7ABC BAYHAM STREET CAMDEN LIFESTYLE

SECTION 73 PROPOSED SCHEME AMENDMENTS
PLANNING APPLICATION
NOVEMBER 2020

This document has been prepared to present the amendments to the consented scheme (Ref: 2018/3647/P) which are predominantly internal and designed to suit the hotel brand.

BASEMENT 2

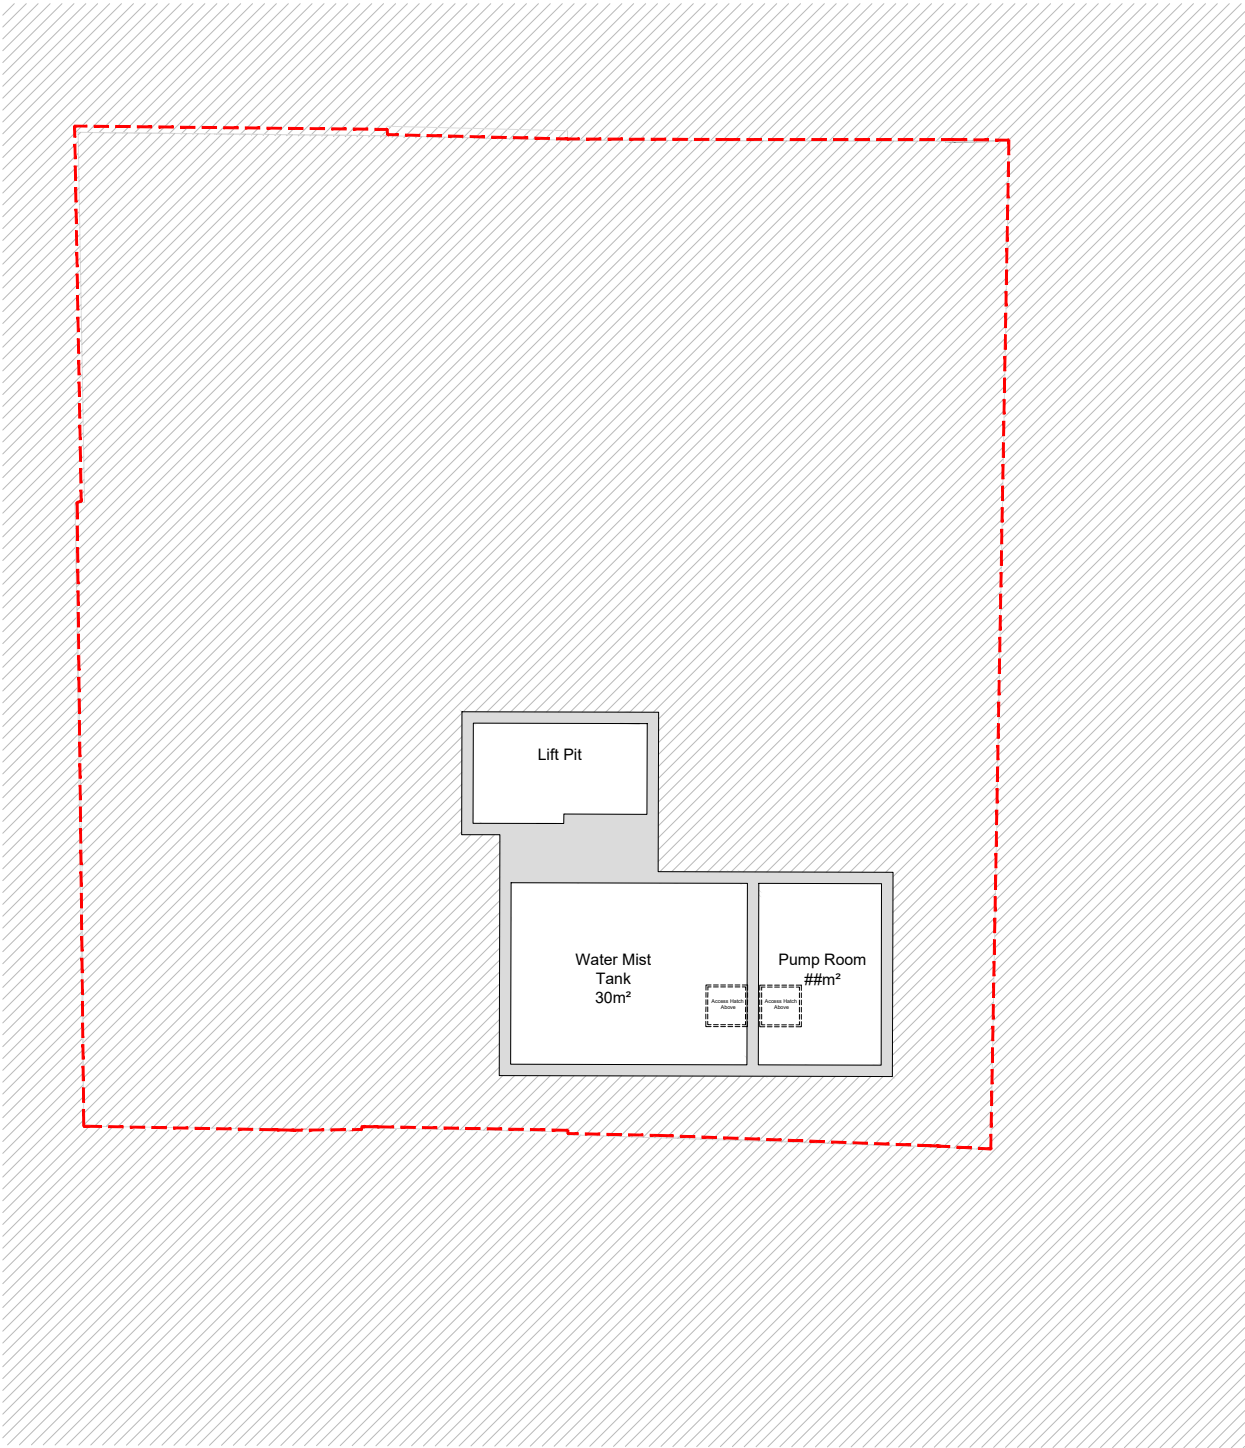
The previous scheme lacked sufficient space for plant and servicing. The new Basement -2 level solely accommodates for fire life safety sprinkler tanks with hatch access from Basement -1. The fire sprinkler system is essential as it aligns the fire strategy with current regulations for life safety.

BASEMENT -1

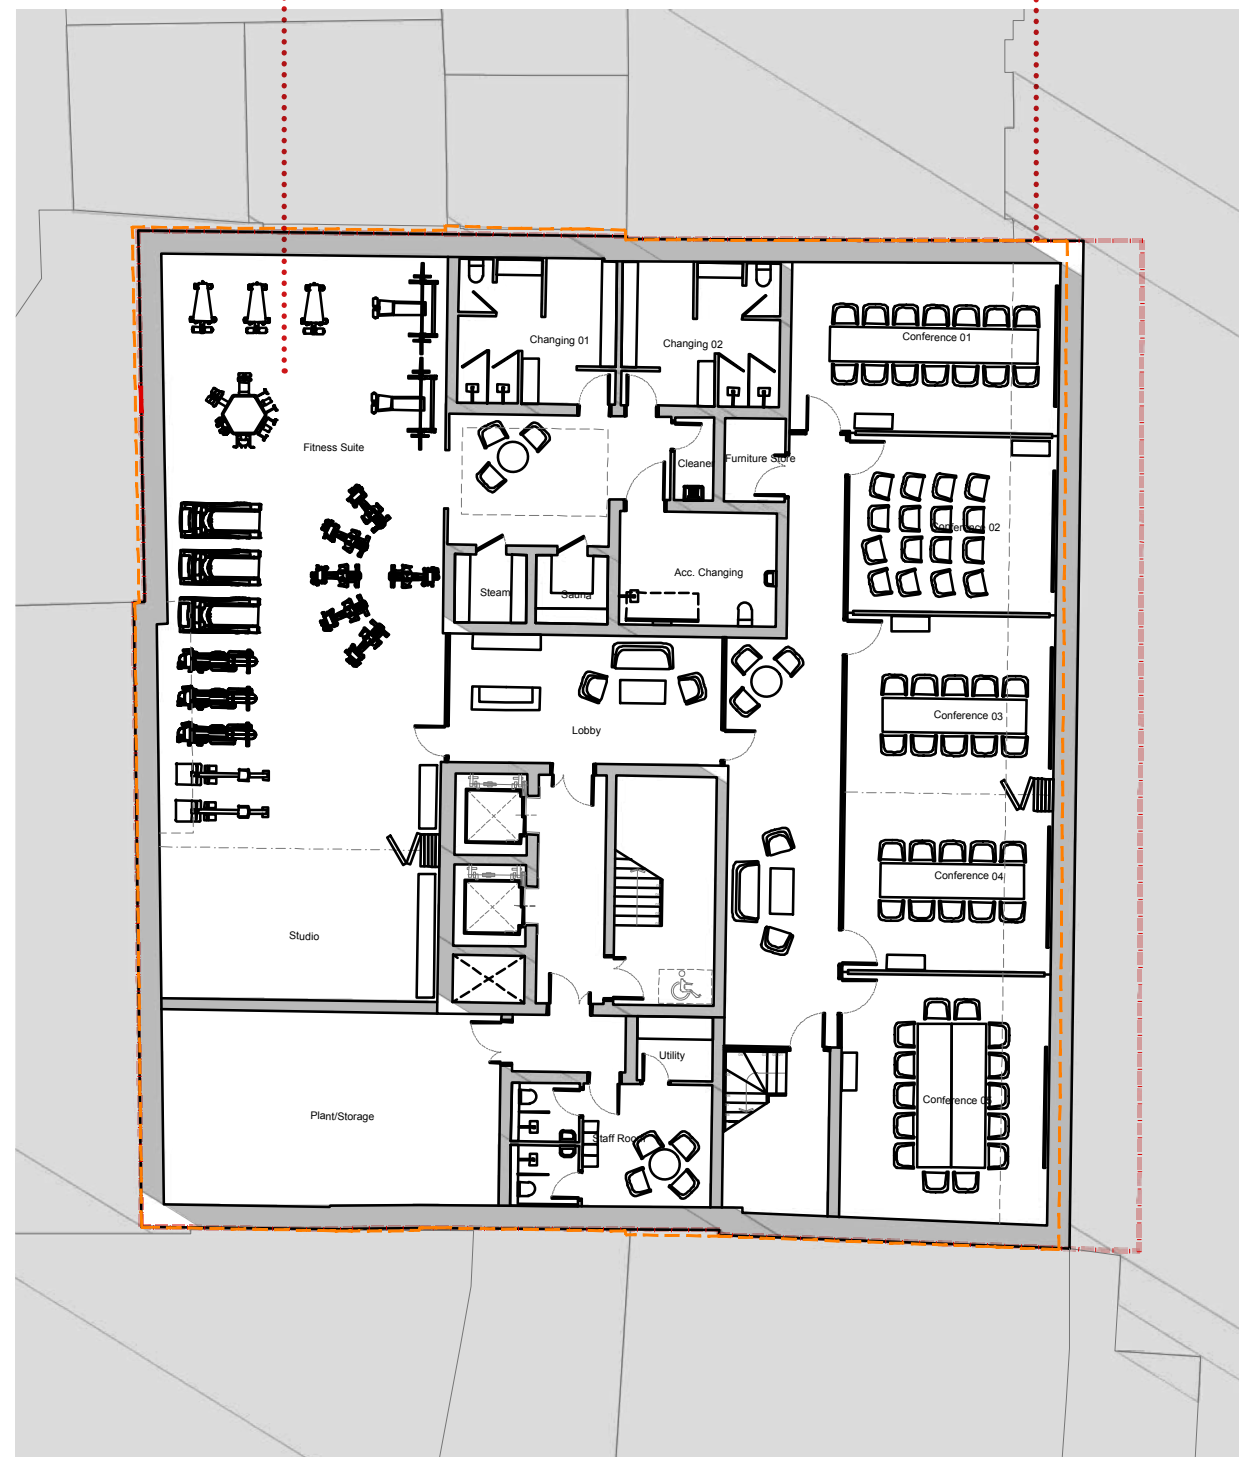
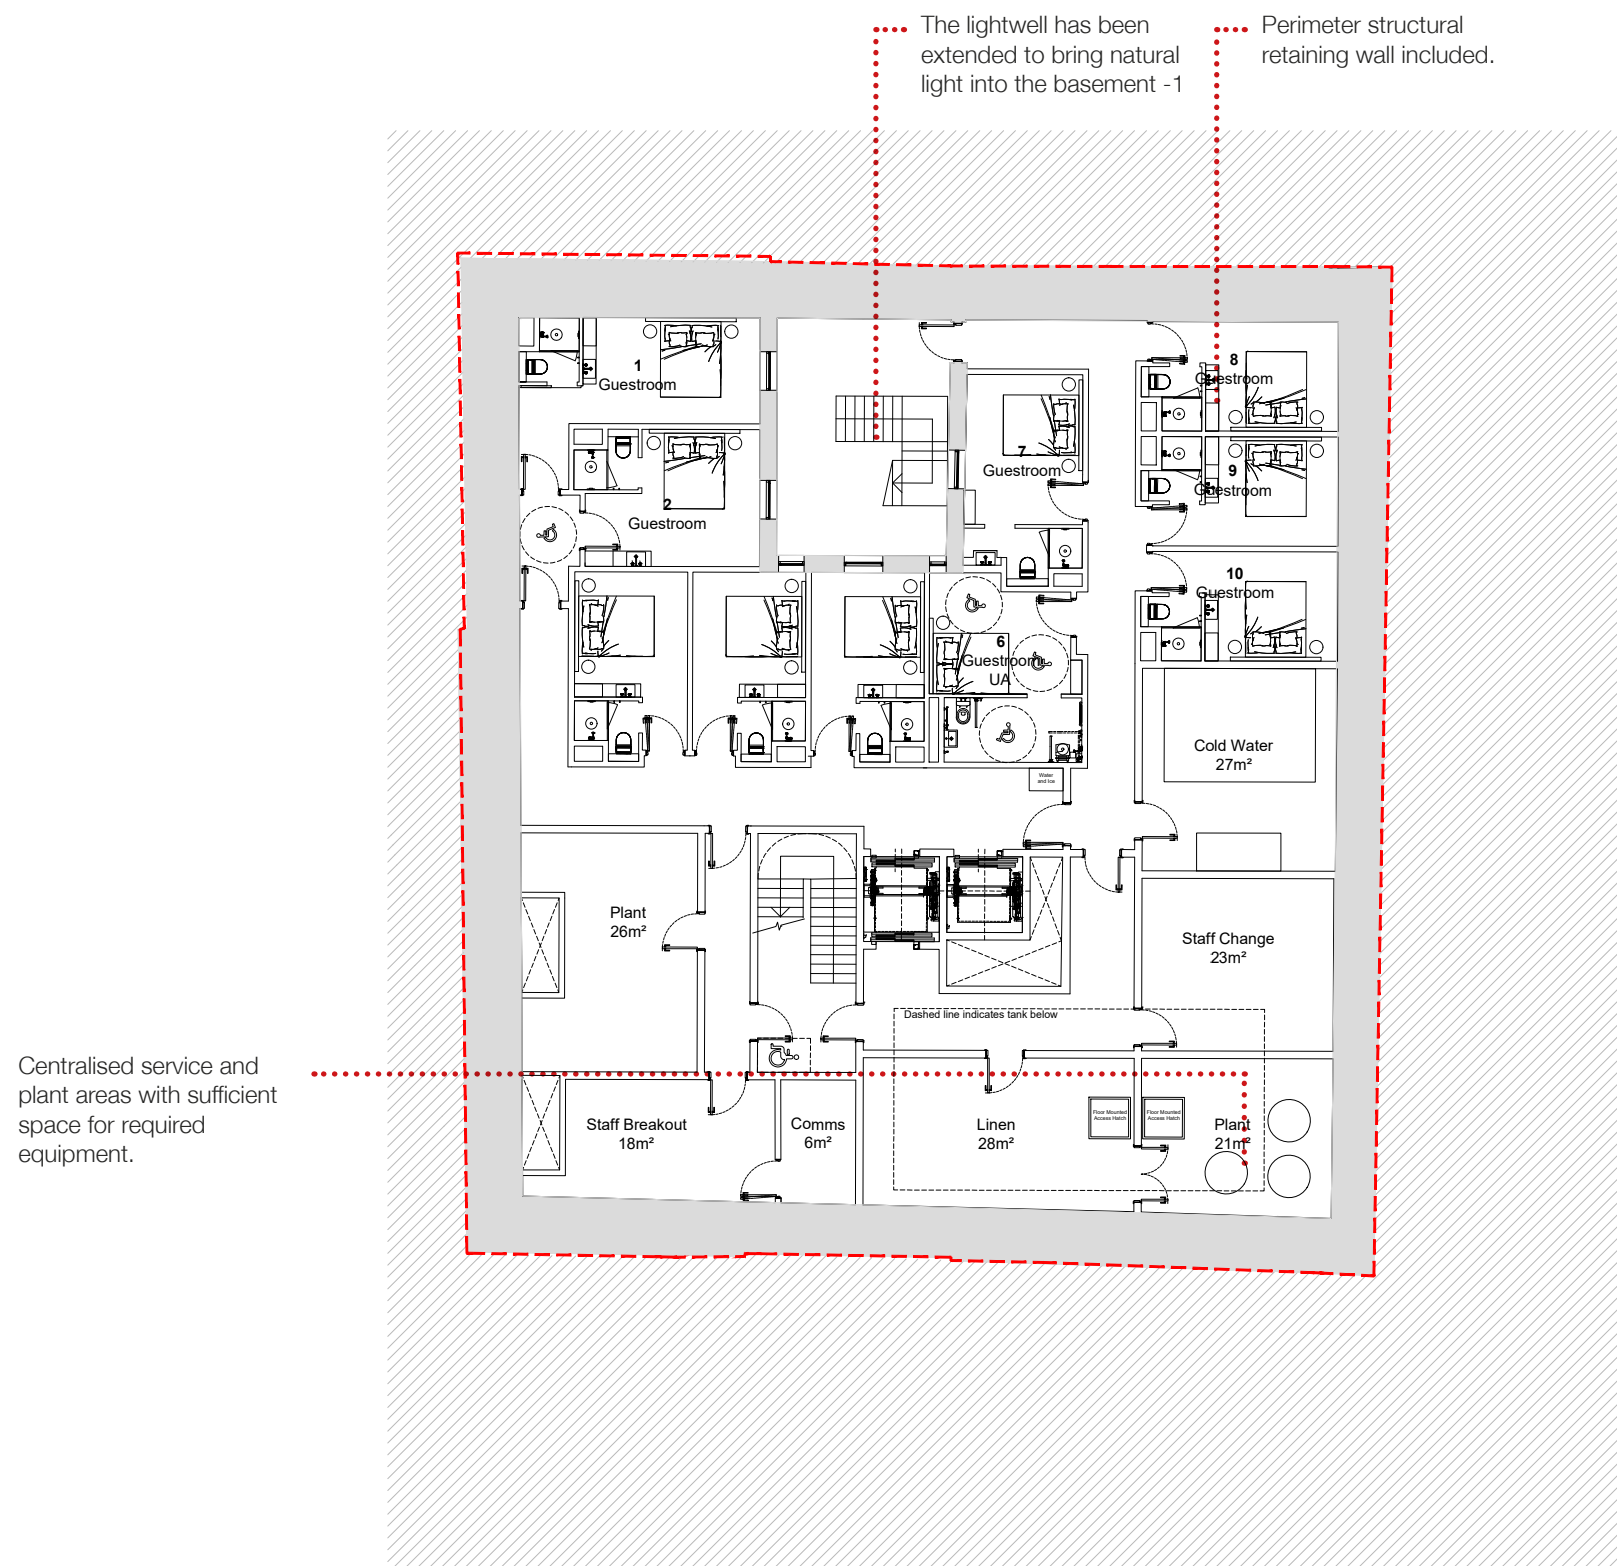
..... Oversize gym for the proposed hotel use but too small for public use.

..... Consented scheme shows nominal structural wall for basement.

The footprint of Basement -1 has been modified following coordination with the structural engineers, introducing a perimeter structural retaining wall.

- Introduction of 10 basement level guest rooms, only four of which are windowless.
- Improvement of BOH staff facilities and circulation.
- Increased provision of plant space; the direct result of detailed coordination with the MEP consultant to ensure plant and hotel services can function adequately and efficiently.
- Omission of the gym.
- Basement footprint reduced to allow for perimeter structural retaining wall; detailed coordination with Structural Engineer to ensure buildability.
- The consented scheme included for the installation of a CHP unit to provide LTHW for the scheme, however it became apparent insufficient MEP plant space had be included for the gas metering and thermal water storage.
- Existing planning condition 12 also required excessive ventilation for the CHP unit, this space allowance was not included in the space plans for the consented scheme.

LOWER GROUND

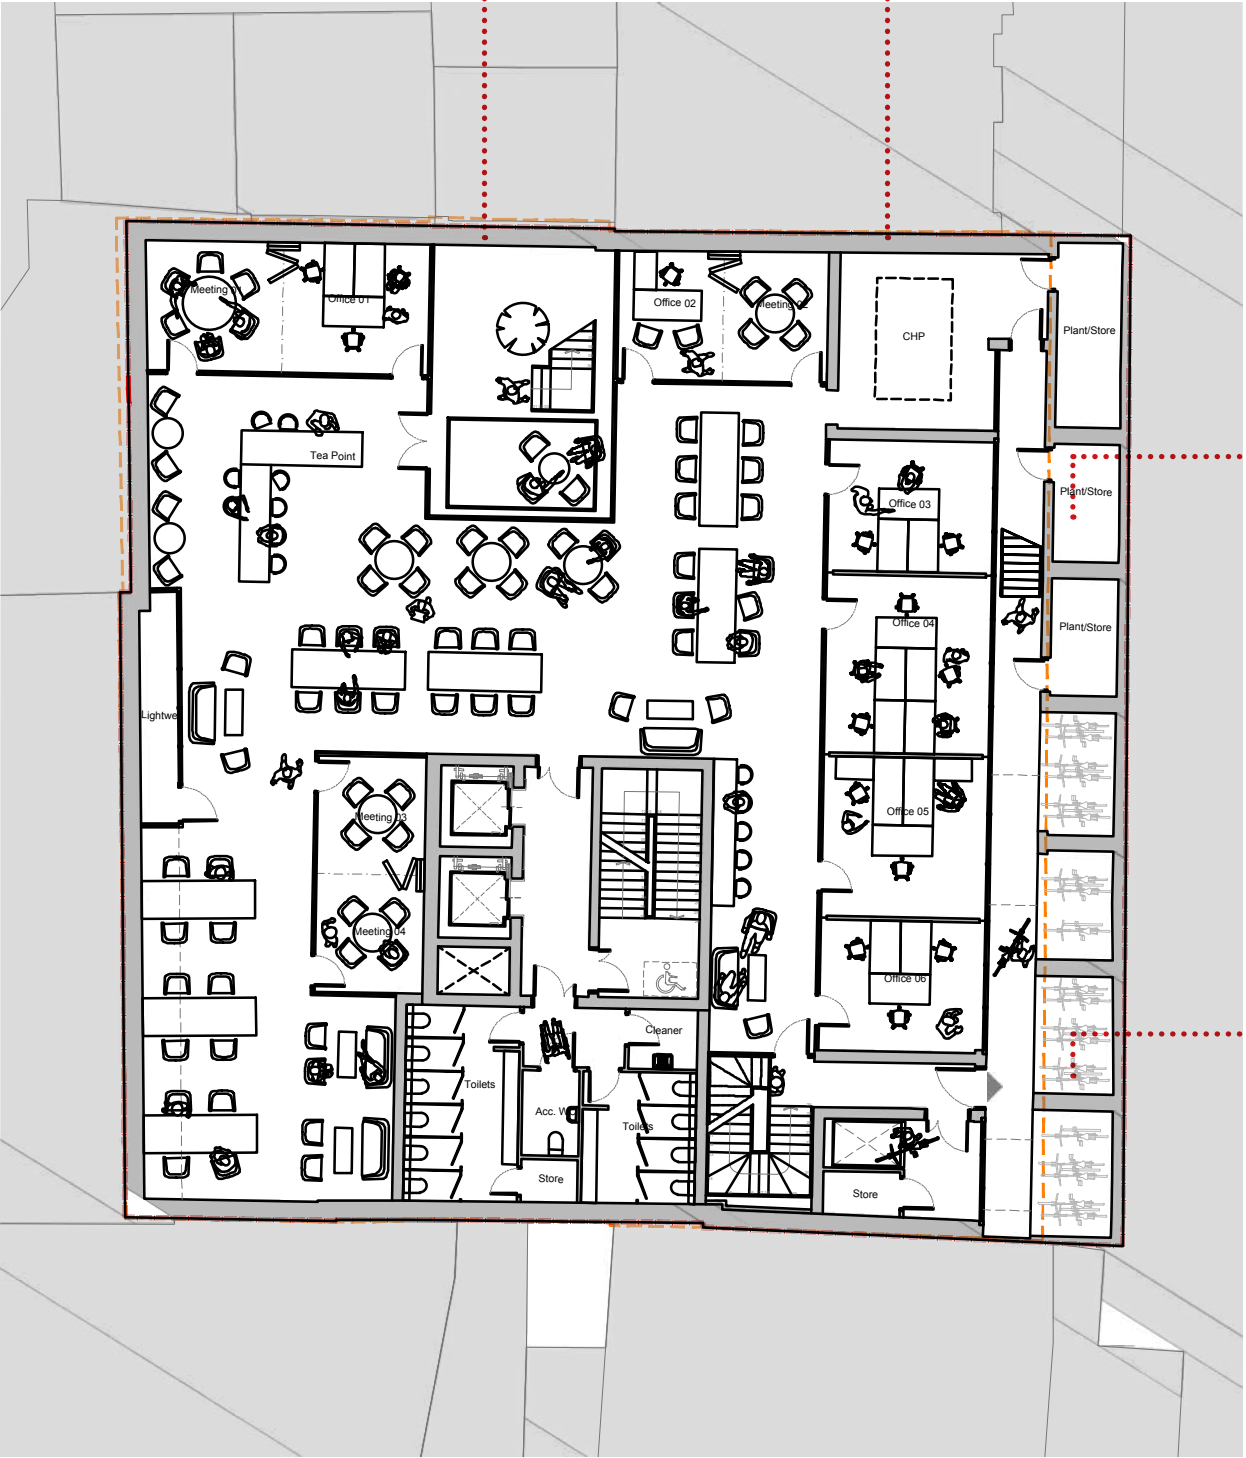
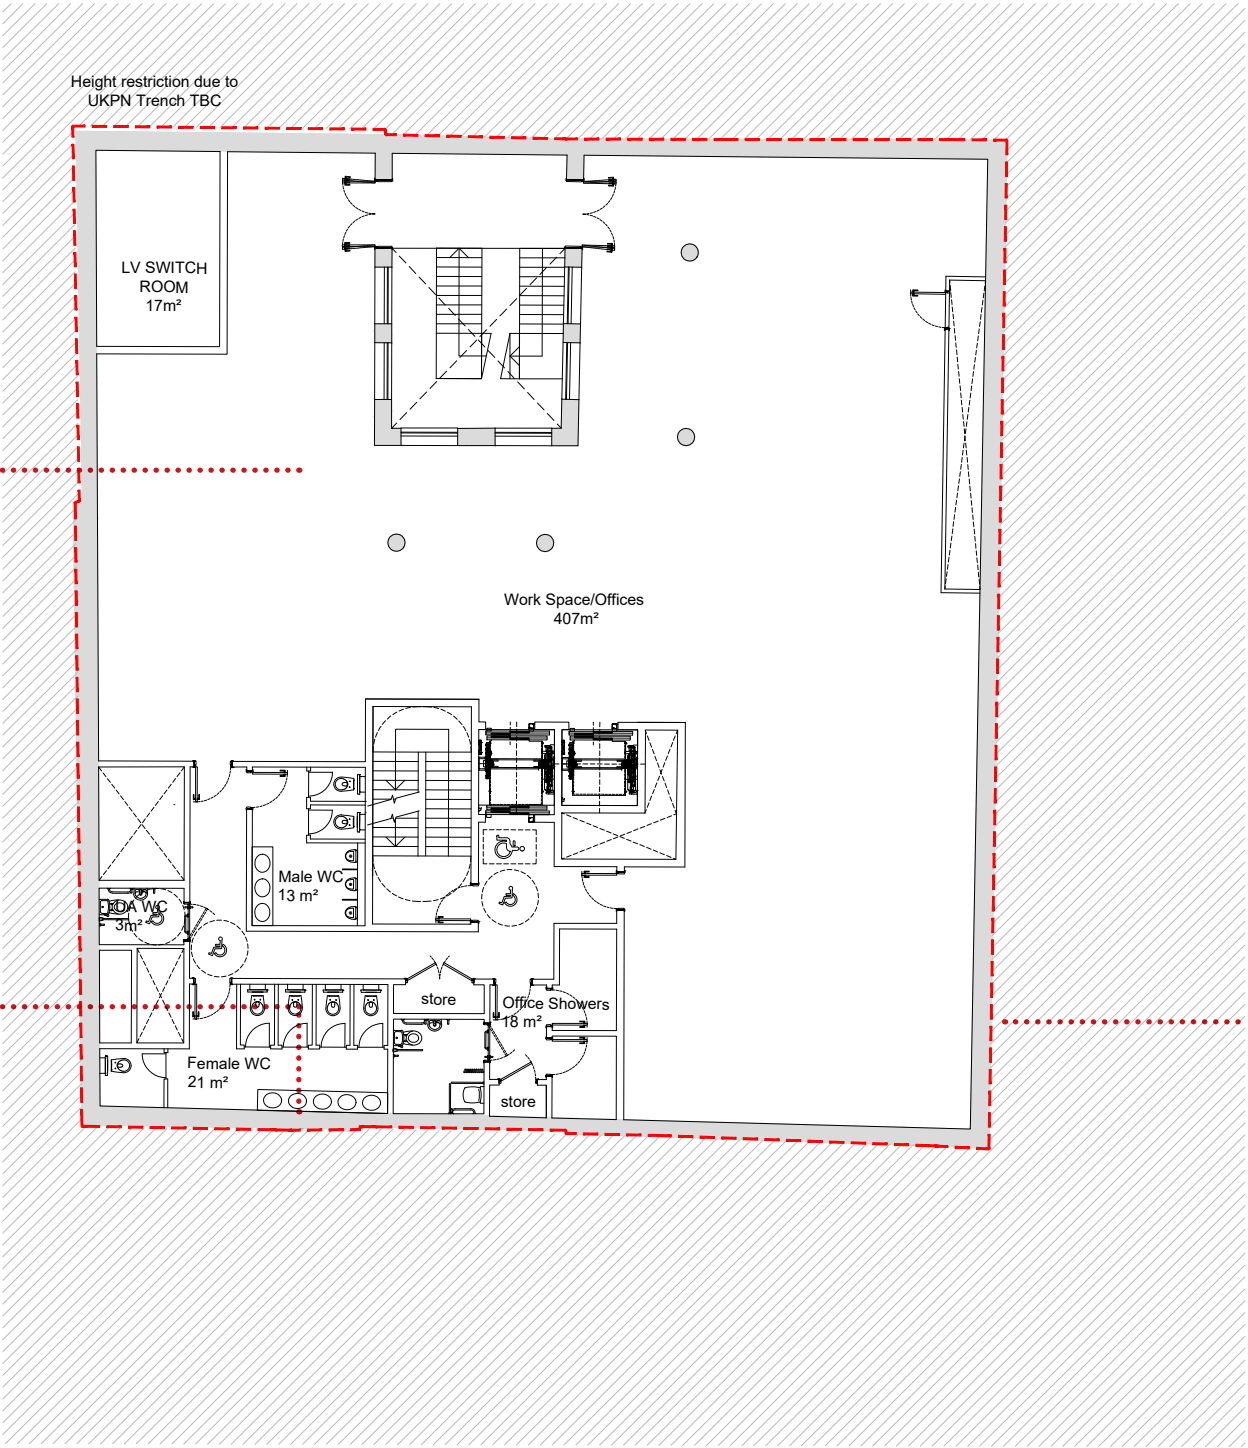
The consented scheme was proposing a green wall at this level. The north facing facade won't have natural light enough to keep plants alive.

Service provision not adequate for the hotel operation, size and offer. No provision for dedicated life saving systems.

Consented scheme built outside of building line.

Cycle store access via lift through ground floor not convenient.

- Office use retained but reduced in area due to the retaining wall and the new proposal being within the site boundary.
- Proposals now provide 540 sqm GIA of B1a office use space compared to an existing 530sqm on site currently.
- Centralised toilet facilities allowed for.
- One front light well omitted to allow for servicing and access routes at ground floor level.
- Front access stair removed from lightwell to avoid security risk and to improve daylight quality within basement areas.
- The consented scheme included for the installation of a CHP unit to provide LTHW for the scheme, however it became apparent insufficient MEP plant space had be included for the gas metering location and the thermal water storage.
- Existing planning condition 12 also required excessive ventilation for the CHP unit, this space allowance was not included in the space plans for the consented scheme.

Office internal layout to be determined by client and interior design team.

Centralised WC and shower location.

Lightwell omitted to allow for better servicing at ground floor level.
